Comment Letter on Hinkson Creek TMDL from Lathrop & Gage

Re: Hinkson Creek Total Maximum Daily Load Comments

Exhibit 1. Side-by-side boxplots of daily average flows for 1967 and 2007 (USGS 06910230 Hinkson Creek in Columbia, MO)

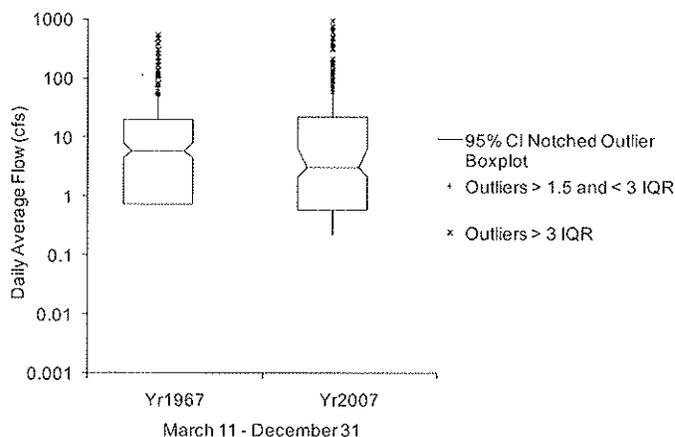
statistically different from each other based on the non-parametric Mann-Whitney test ($p=0.95$).

The lack of statistical difference between the median daily average flow for 1967 and 2007 indicates that *the data do not support the claim that the flow regime in the creek has been significantly changed*. It is not clear why a truncated period of record was selected.

Exhibit 1. Side-by-side boxplots of daily average flows for 1967 and 2007 (USGS 06910230 Hinkson Creek in Columbia, MO)

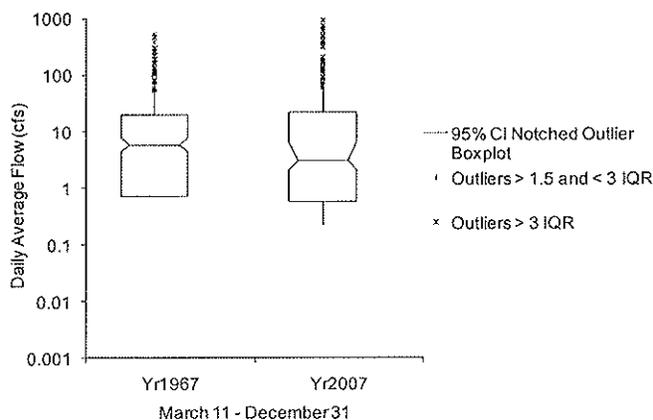
- In Table 8, precipitation and flow statistics for 1967 and 2007 are compared for the April 1 – July 31 period. Why are only 4 out of 12 months of available data being used to describe precipitation and runoff? Should MDNR believe that conclusions drawn from fall biological surveys are relevant in assessing use attainment in Hinkson Creek, it would seem appropriate that flow data collected in the late summer/ fall season also be incorporated into hydrologic analyses and comparisons. How do we know that antecedent precipitation regimes did not influence the results a 4-month comparison? Furthermore, as precipitation and streamflow data generally do not follow a normal statistical distribution, we question the use of the arithmetic means to describe central tendencies. If the period of record is expanded to all available and comparable months for 1967 and 2007 (March 11 – December 31, n=296), we note that the median, geometric mean, and cumulative Period of Record (POR) streamflow values for 1967 (median=5.75 cfs) are greater than values for 2007 (median= 3.05 cfs). Side-by-side boxplots of the two data sets (Exhibit 1) indicate both years have very skewed daily average flows, *which suggests that the arithmetic mean is a biased estimator* and the median is a more appropriate metric of the central tendency of data. More importantly, the medians are not statistically different from each other based on the non-parametric Mann-Whitney test (p=0.95).

The lack of statistical difference between the median daily average flow for 1967 and 2007 indicates that *the data do not support the claim that the flow regime in the creek has been significantly changed*. It is not clear why a truncated period of record was selected.

Exhibit 1. Side-by-side boxplots of daily average flows for 1967 and 2007 (USGS 06910230 Hinkson Creek in Columbia, MO)

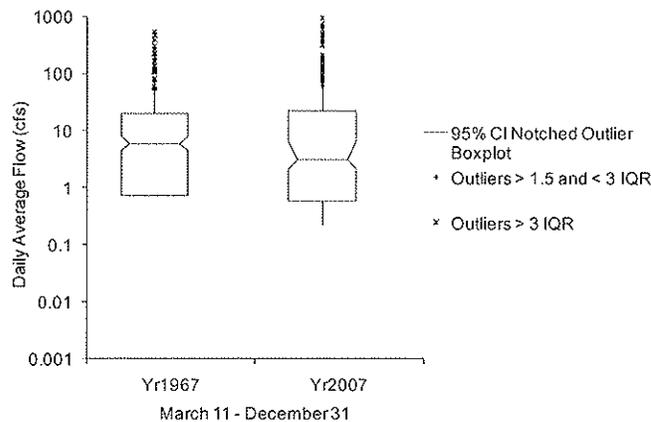
- In Table 9, precipitation and flow statistics for 1967 and 2007 are compared for the April 1 – July 31 period. Why are only 4 out of 12 months of available data being used to describe precipitation and runoff? Should USEPA believe that conclusions drawn from fall biological surveys are relevant in assessing use attainment in Hinkson Creek, it would seem appropriate that flow data collected in the late summer/ fall season also be incorporated into hydrologic analyses and comparisons. How do we know that antecedent precipitation regimes did not influence the results of a 4-month comparison? Furthermore, as precipitation and streamflow data often do not follow a normal statistical distribution, we question the use of the arithmetic means to describe central tendencies. If the period of record is expanded to all available and comparable months for 1967 and 2007 (March 11 – December 31, n=296), we note that the median, geometric mean, and cumulative Period of Record (POR) streamflow values for 1967 (median=5.75 cfs) are greater than values for 2007 (median= 3.05 cfs). Side-by-side boxplots of the two data sets (Exhibit 1) indicate both years have very skewed daily average flows, *which suggests that the arithmetic mean is a biased estimator* and the median is a more appropriate metric of the central tendency of data. More importantly, the medians are not statistically different from each other based on the non-parametric Mann-Whitney test (p=0.95).

The lack of statistical difference between the median daily average flow for 1967 and 2007 indicates that *the data do not support the claim that the flow regime in the creek has been significantly changed*. It is not clear why a truncated period of record was selected.
